Service Bulletin

Bulletin No.: PI0984

Subject: Revised Liftgate Strut Replacement Procedure

Models: 2008-2012 Buick Enclave
2009-2012 Chevrolet Traverse
2007-2012 GMC Acadia
2007-2010 Saturn OUTLOOK

2878222

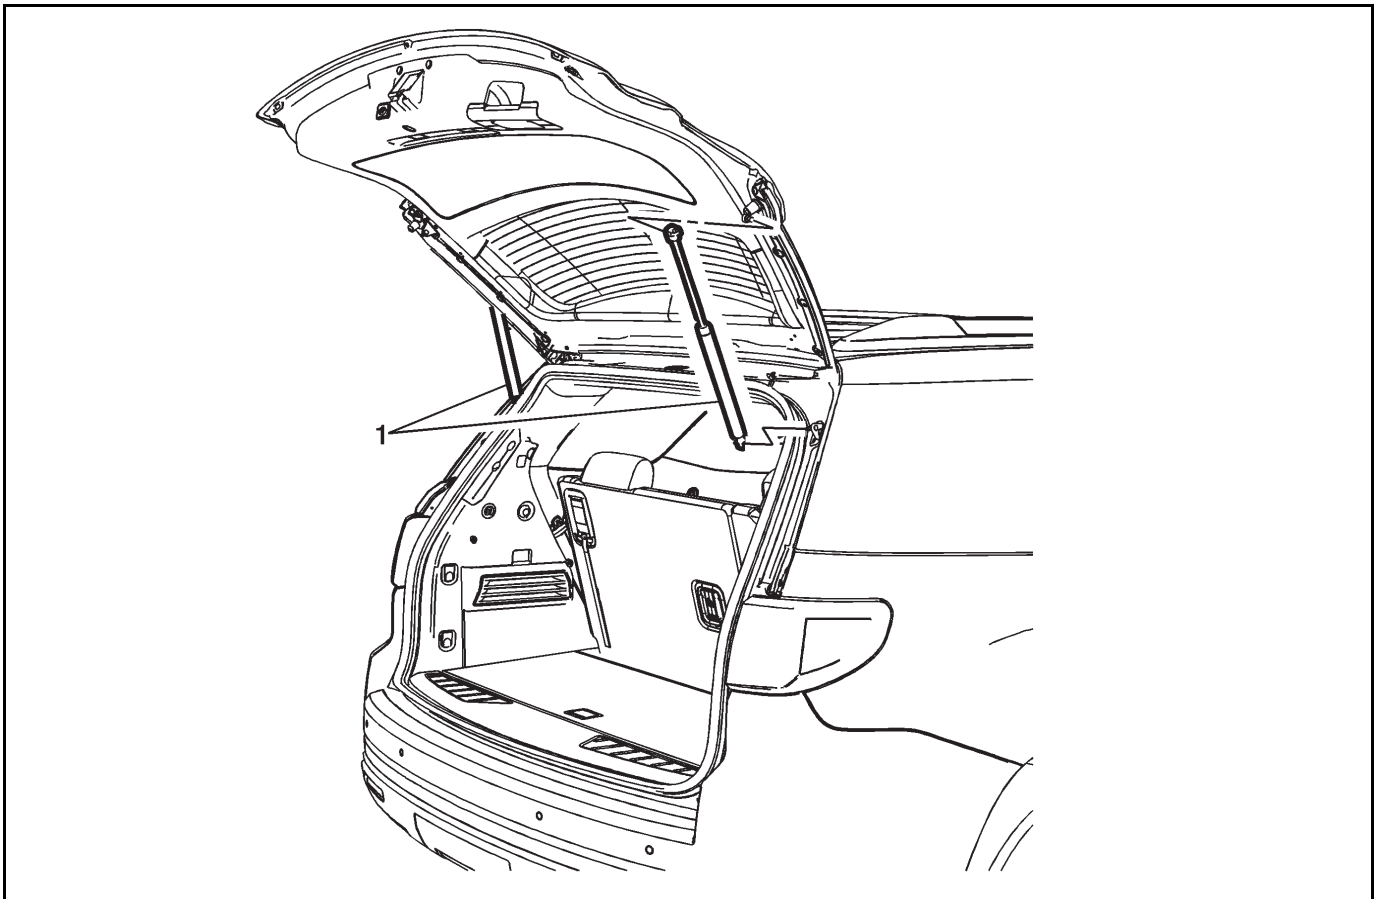
GM engineering has determined that improved durability of the liftgate strut can be realized by installing the strut assembly with the rod side down. In this orientation, dust and dirt does not collect on the strut housing to rod seal, which can cause wear on the seal.

When it is necessary to replace a liftgate strut, install the strut assembly with the strut body end attached to the body side of the vehicle and the rod side attached to the liftgate (1).

Important: This revised installation procedure applies to all vehicles even if the struts were installed in a different orientation from the factory.
